1400 SERIES A, B AND C AND CHECK VALVE KITS

19	Check Valve Kit	271885
----	-----------------	--------

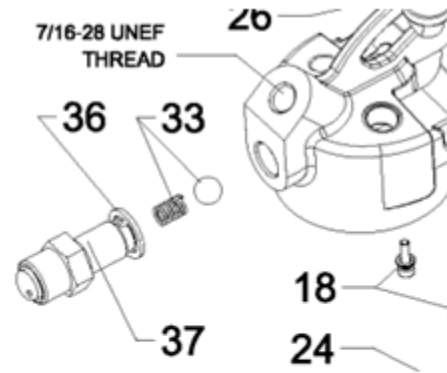
the 1400 series A and B
uses **271885**?
What is the thread size?

The 1400 Series C uses
286317?
What is the thread size?

They are not
interchangeable?

**Those checks are not interchangeable. the port on
the gun is machined differently between the two.
See the drawings below.**

1400 Series A & B
½ - 20 UNF-2A

1400 Series C
M14 x 1.5
